ITEM: 6.11	REPORT SUMMARY MINOR VARIANCE APPLICATION FILE NUMBER A235/22
-------------------	--

MINOR VARIANCE APPLICATION FILE NUMBER A235/22

CITY WARD #:	1
APPLICANT:	Harwinder & Jessica Kalsi
AGENT:	PMP Design Group Inc
PROPERTY:	15 Cardish Street, Kleinburg
ZONING DESIGNATION:	See below.
VAUGHAN OFFICIAL PLAN (2010) DESIGNATION:	Vaughan Official Plan 2010 (VOP 2010): "Low-Rise Residential"
RELATED DEVELOPMENT APPLICATIONS:	None
PURPOSE OF APPLICATION:	Relief from the Zoning By-law is being requested to permit a pergola (on Part 1) and cabana (on Part 2), a swimming pool (hot tub), the location of pool equipment in the easterly side yard and reduced landscaping requirements in the rear yard.

To: Christine Vigneault, Committee of Adjustment Secretary Treasurer
From: Nancy Tuckett, Director of Development Planning
Date: September 19, 2024
Name of Owner: Harwinder Kalsi
Location: 15 Cardish Street
File No.: A235/22

DWG. **PROPOSED CABANA PART#2**

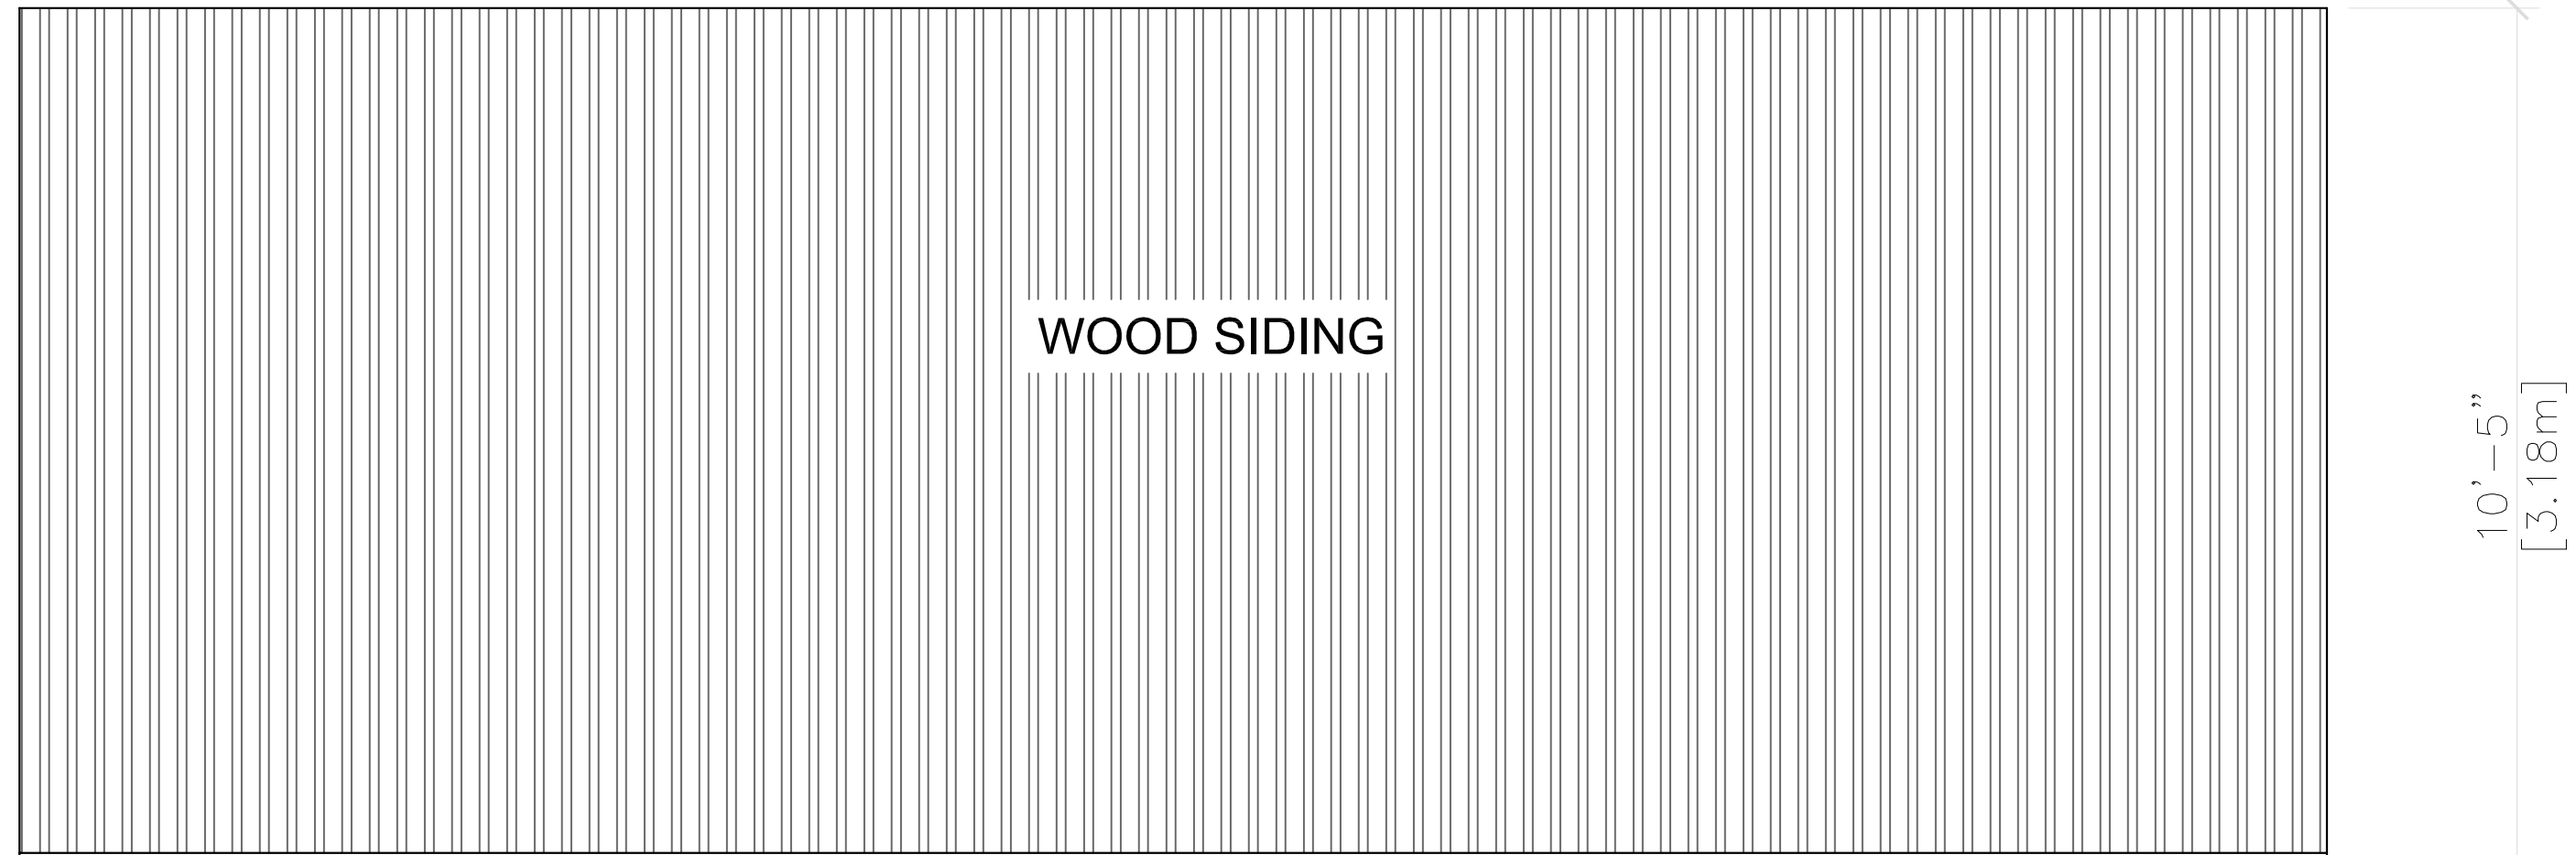
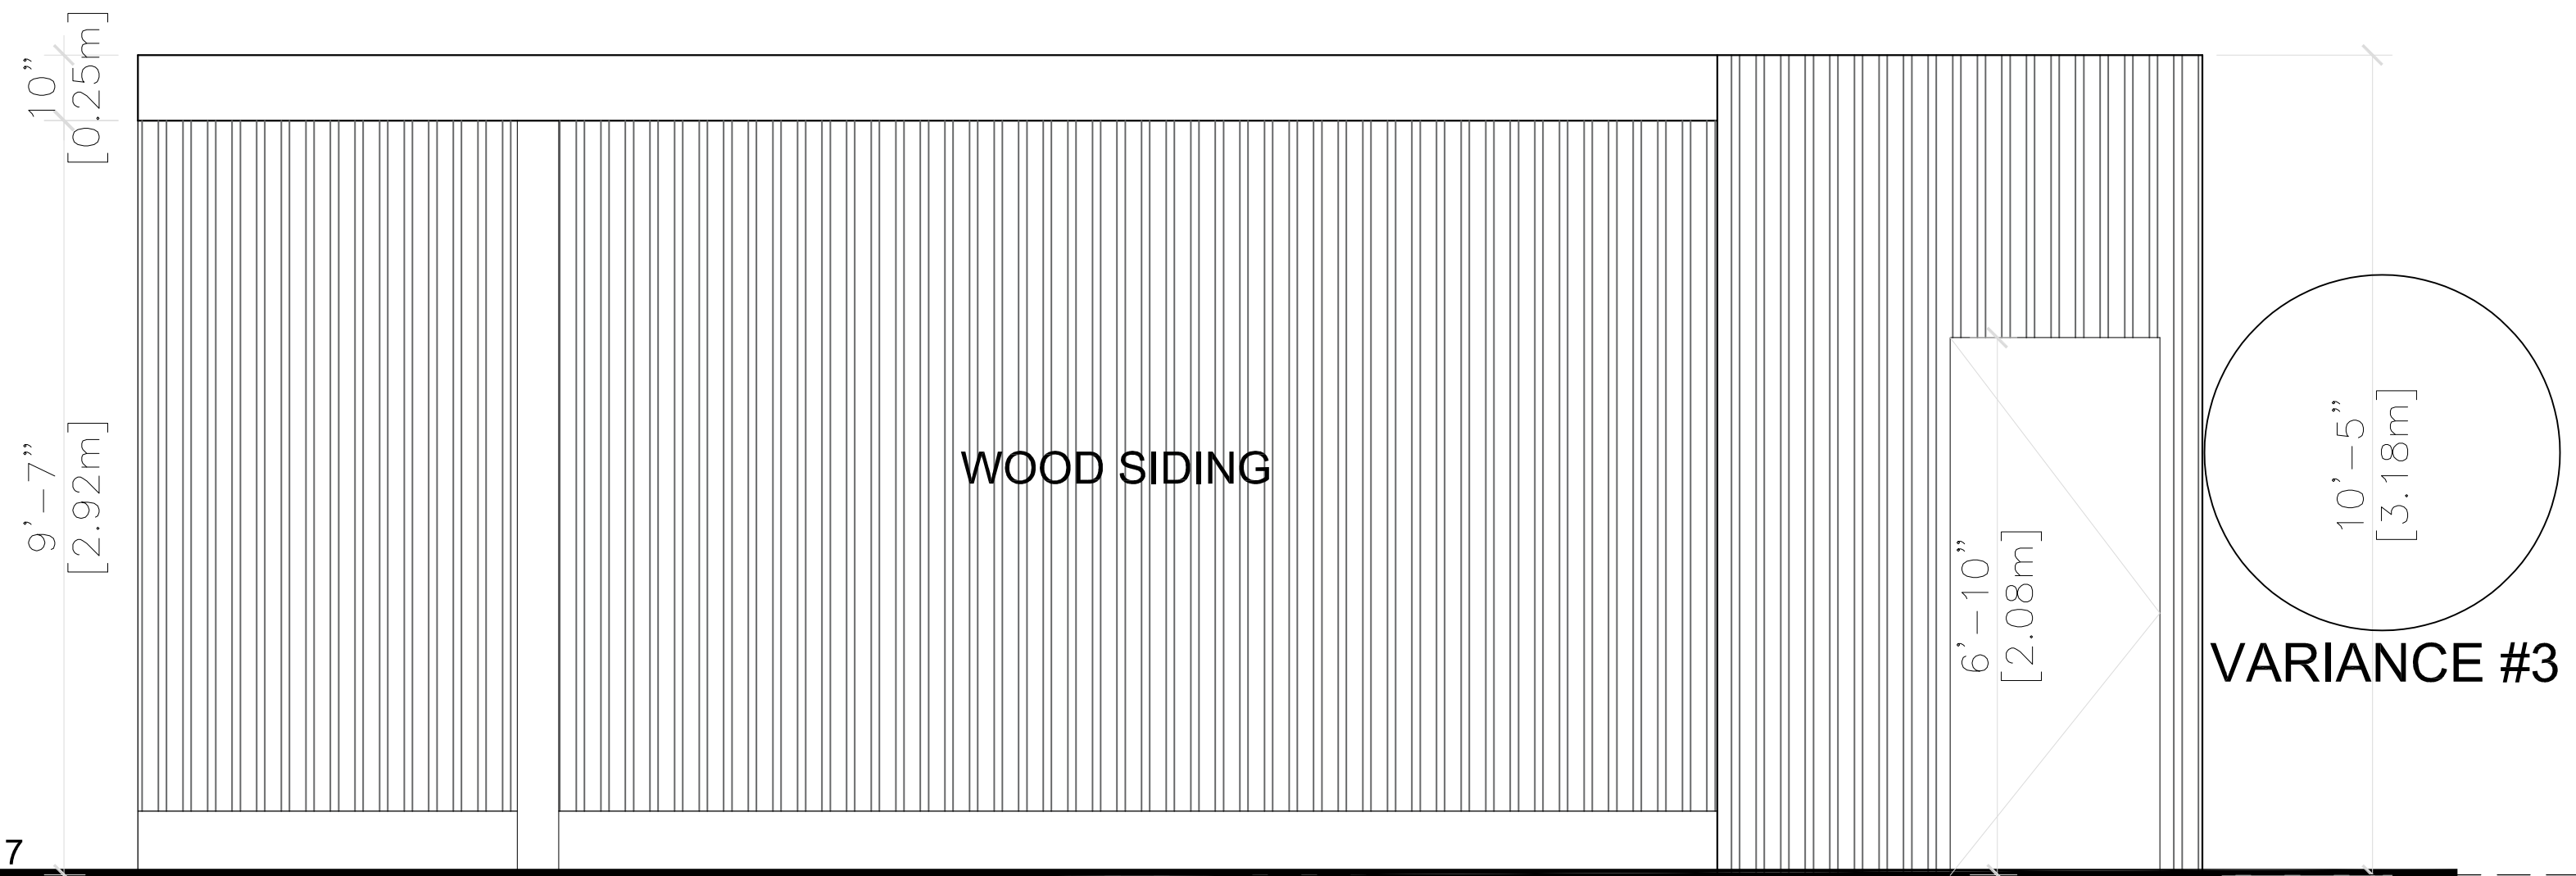
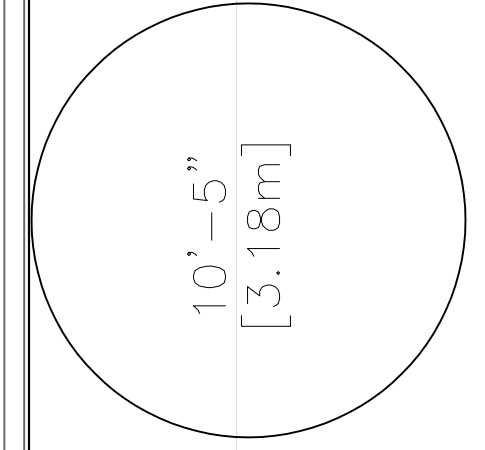
The Development Planning Department has no objection to Variances 2 and 5 to permit encroachments into the minimum required distances from the easterly interior side lot line (Variance 2) and rear lot line (Variance 5) for the proposed cabana which is partially constructed with an enclosed storage room (identified as part 2 on the site plan) that has a maximum height of 3.18 m. The cabana is proposed to have a flat roof design with the requested relief measured between the established grade to the top of the roof. The cabana is proposed to be enclosed on all but the west side facing the pool with the exception of the storage room at the rear which will be fully enclosed and combines for less than half of the length of the accessory structure. The proposed minimum setbacks from the interior side lot line (0.65 m) and rear lot line (2.03 m) for the cabana are not anticipated to pose significant adverse impacts to the abutting property to the east (21 Cardish Street) or the south (38 Rushworth Crescent) as the eave projections are minimal. Sufficient space for maintenance and safe access is provided between the cabana and the property lines and an adequate amount of space between the structure and the dwelling are also provided to mitigate potential adverse massing impacts along the east lot line. Adverse massing impacts resulting from the cabana's east wall's proximity to the east lot line due to its length is further mitigated by the existing tall wooden privacy fence. 21 Cardish Street contains a number of mature trees along the mutual interior side lot line, providing a vegetative buffer between its rear yard and the cabana considered in this application. Additionally, at the rear, the cabana abuts an existing residential accessory structure in the rear yard of the abutting property to the South (38 Rushworth Crescent). Development Engineering Department Staff have also reviewed the proposal and are satisfied that drainage will be maintained. As such, staff are of the opinion that the proposed cabana will have minor massing and visual (privacy) impacts on the properties to the south and the east.
